Amendments to the Drawings:

Appln. No. 10/753,246
312 Amdt. Dated April 5, 2006
Reply to Notice of Allowance dated February 28, 2006
Annotated Sheet Showing Changes

FIG. 2

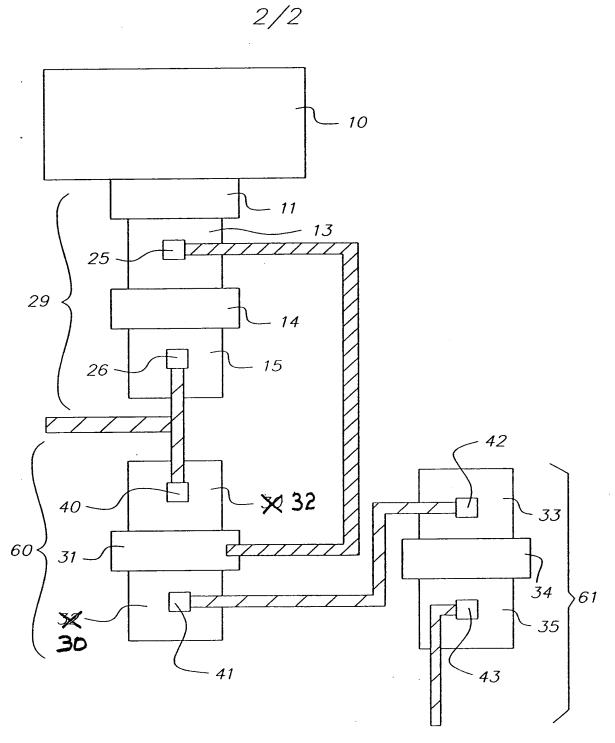
The attached sheet of drawings includes changes to Figure 2 (Fig.

2). This sheet replaces the original Figure 2. The drawing inadvertantly transposed the position of the source and drain of the source follower. Approval by the Examiner is respectfully requested.

The amendment to the specification is made to correspond to the transposition of the reference numerals in Fig. 2 as discussed hereinabove.
